INSTALLATION INSTRUCTIONS

PART NUMBER	154-8853Z
PART DESCRIPTION	A1 PROGRAM UPGRADE KIT
REV DATE	5/2/2014
MACHINE MODELS	KUSTODIAN PLUS

KPLUS WIRING AFTER INSTALLING PROGRAM A1

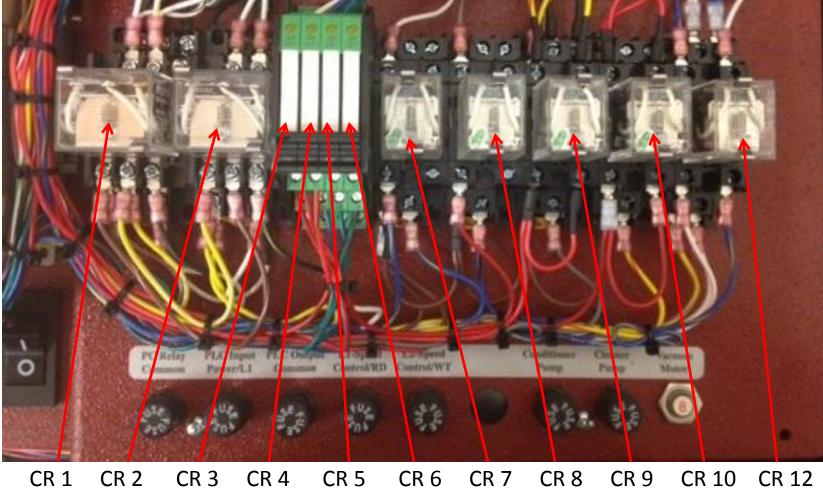
- 1. Move the Brown wire off of CR9-7 and reconnect it to CR9-8. This is to correct the polarity of the coil for the LY2 Diode Relay.
- 2. Move the Brown wire off of CR10-7 and reconnect it to CR10-8. This is to correct the polarity of the coil for the LY2 Diode Relay.
- 3. Move the Grey wire from CR9-8 and reconnect it on CR9-7.
- 4. Move the Yellow/Red wire from CR10-8 and reconnect it on CR10-7.

- 1. Move the Red wire from CR10-6 and reconnect it to CR10-5.
- 2. Move the Red wire from CR9-6 and reconnect to CR10-6.
- 3. Move the Gray wire from CR9-4 and reconnect it to CR9-2 and add small Gray jumper from the kit to CR9-2 to CR9-1.
- 4. Move the Yellow / Red wire from CR10-4 and reconnect it to CR9-4 and add new small Yellow / Red jumper from the kit to CR9-4 to CR9-3.
- 5. Locate Red wire in Kit, each end of the wire will have a small jumper connect one end to CR10-4 and CR10-3 then connect the other end to CR9-6 and CR9-5 this completes incoming power.

This completes rewiring of CR9 and CR10. CR9 will be known as the Oil Head Reversing Relay and CR10 will be known as the Oil Head Power Relay.

- 1. Remove wires off of CR7-7 and CR7-8. Reconnect the Brown wire to CR7-8, reconnect the Blue / Yellow wire from PLC to CR7-7 and Blue / Yellow wire from speed control to CR7-6.
- 2. Remove wires off of CR8-7 and CR8-8. Reconnect the Brown wire to CR8-8 and reconnect the Blue / Black wire to CR8-7.

Now replace the 4 24-volt coil relays (CR7, 8, 9 & 10) with the NEW 24V RELAY DPDT 10A W/ DIODE (158-1462)
